Installation ADDENDUM

SUBJECT: Pyrometer Thermocouple Installation Warning

**APPLICATION: Fixed Orifice and PRXB™ Exhaust Brakes
2003 and Newer Dodge Trucks with 3.5" and 4" Exhaust
*5.9 Liter Cummins Only**

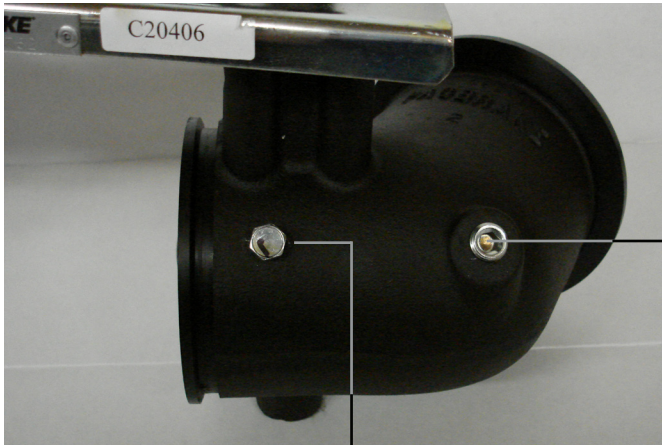
Do not install a pyrometer thermocouple in the back pressure test port, damage to the thermocouple will result.

Pyrometer Thermocouple Port
1/4" NPT

Back Pressure Test Port
1/8" NPT
